AGENDA
PLANNING AND ZONING COMMISSION MEETING
CITY OF CREVE COEUR, MISSOURI
MONDAY, JUNE 6, 2011
7:00 PM

A. Application #11-009: Conditional use permit and site development plan approval for new automated teller machine and landscape improvements for the First Community Credit Union.

A. Application #11-013: Minor site development plan approval for landscape improvements at 211 N. Lindbergh Boulevard

**APPLICATION TO PLANNING AND ZONING COMMISSION
#11-009 FOR A CONDITIONAL USE PERMIT AND SITE DEVELOPMENT
PLAN FOR NEW AUTOMATED TELLER MACHINE AND LANDSCAPE
IMPROVEMENTS FOR THE FIRST COMMUNITY CREDIT UNION**

L1.01

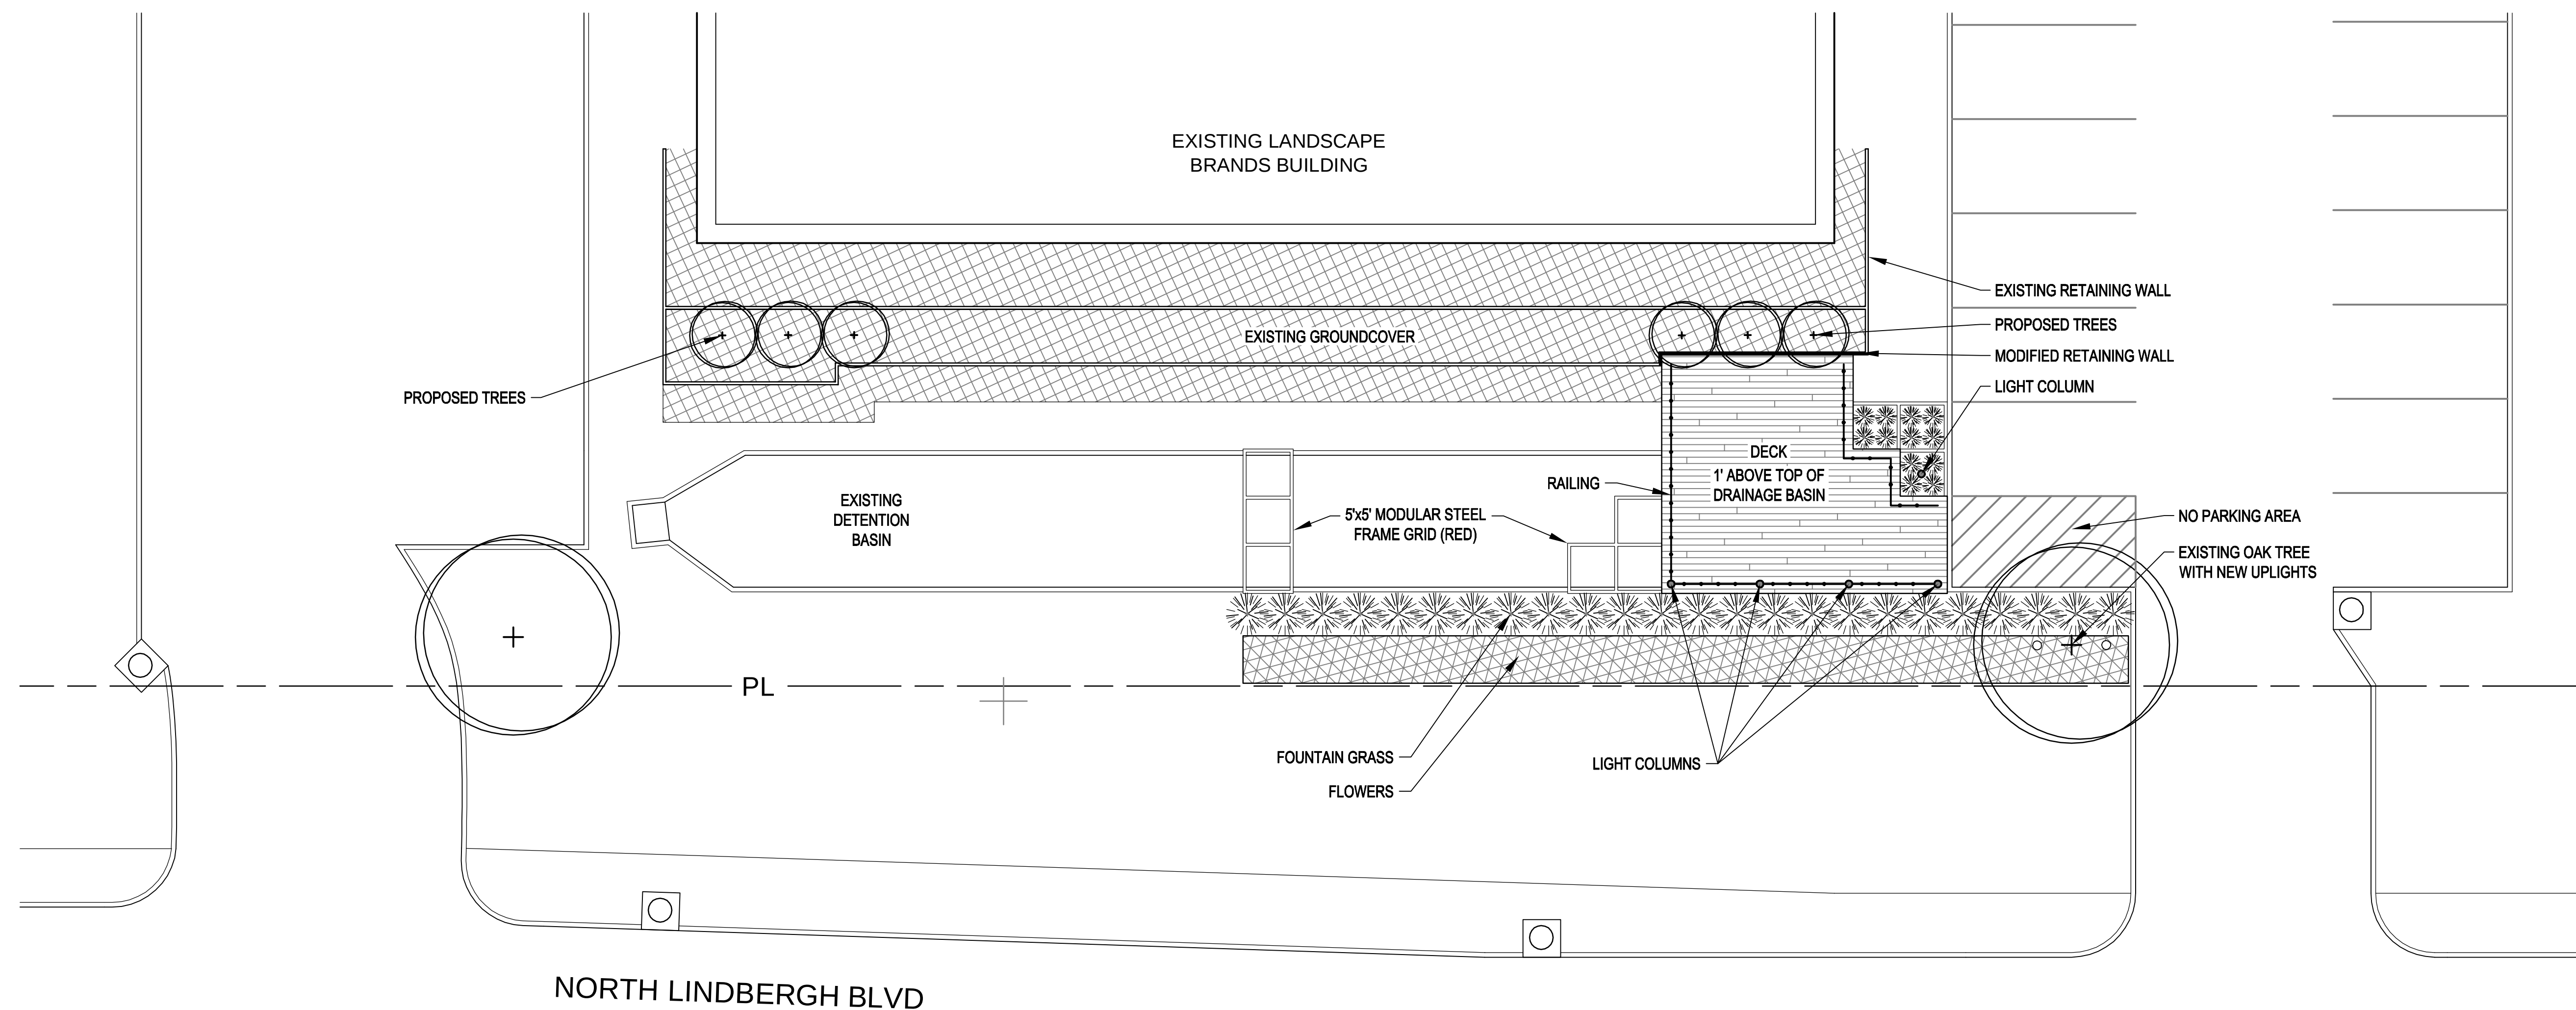
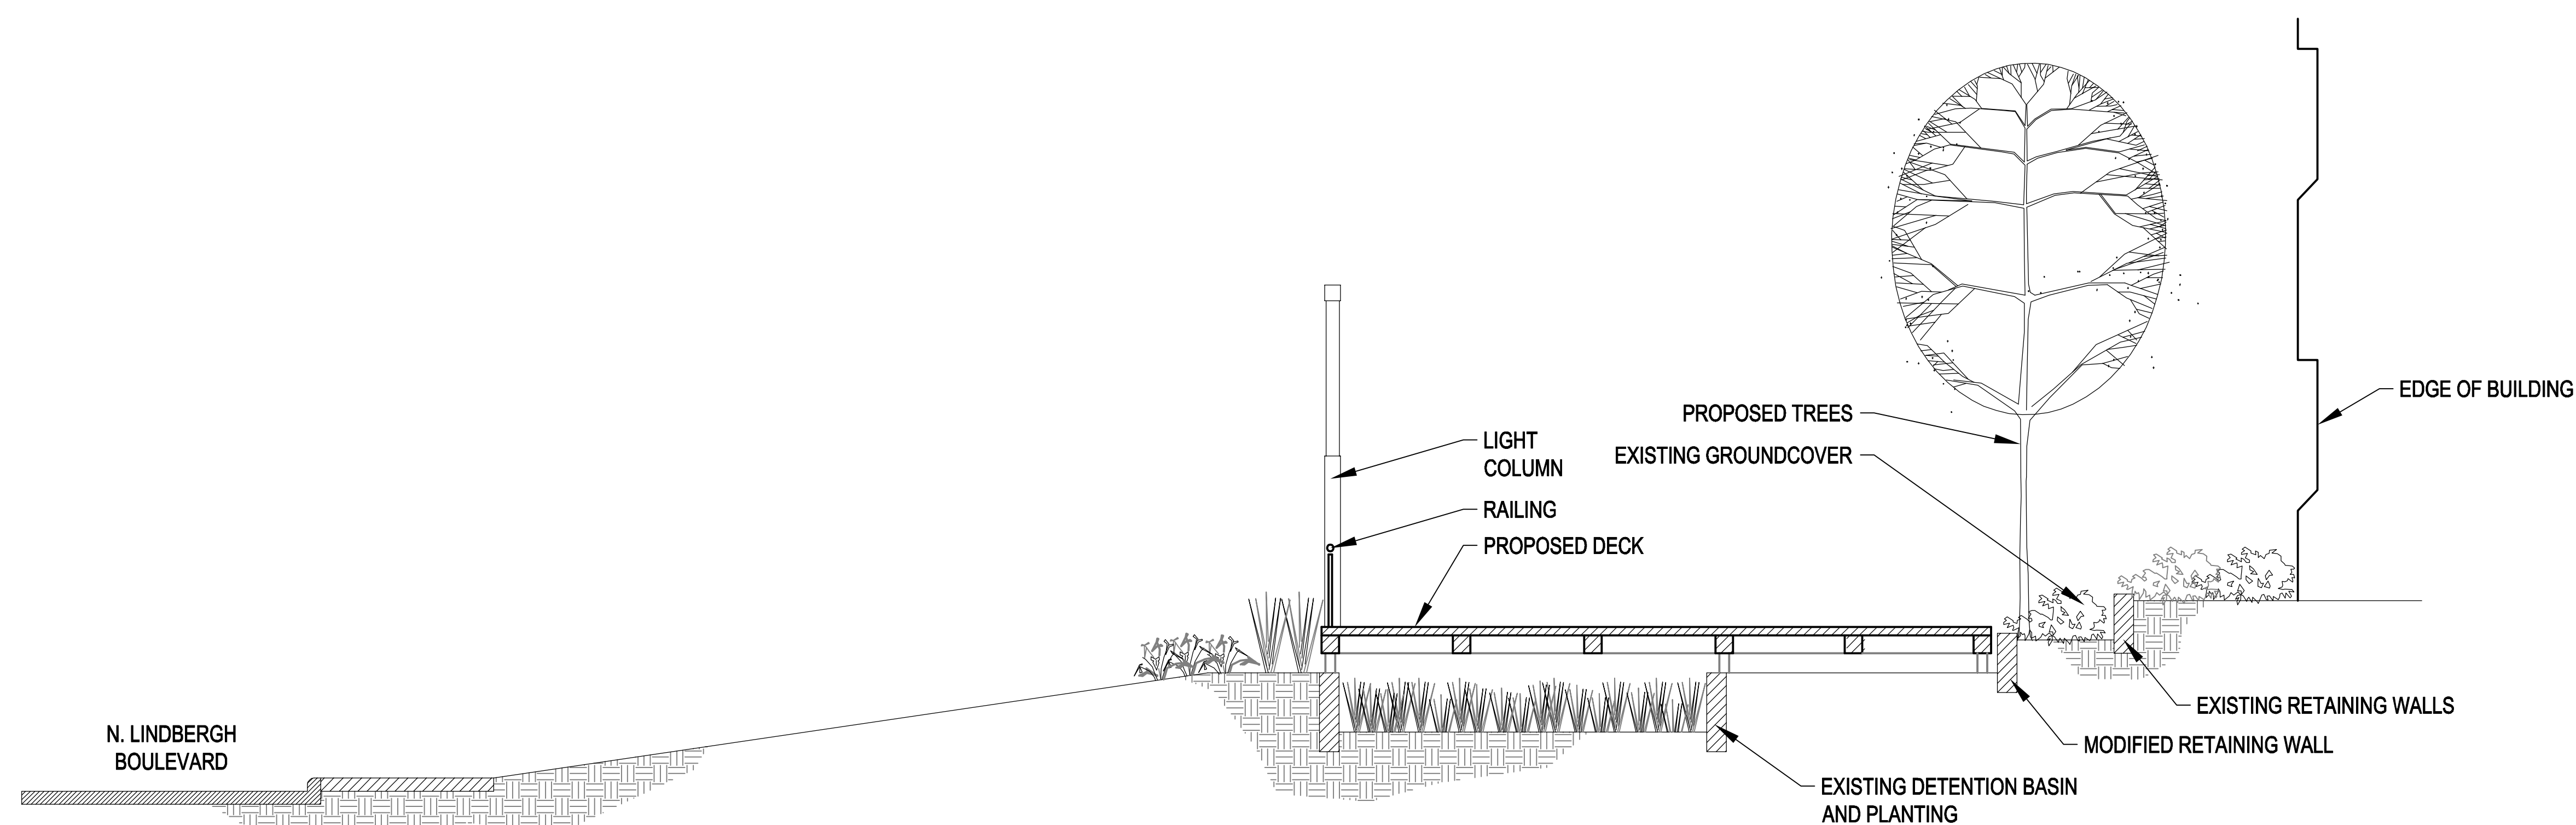
- Does the request further the goals and/or implement the Comprehensive Plan?
- Do the LED lighted columns provide exceptional architectural elements or detail, without causing a distraction to drivers?
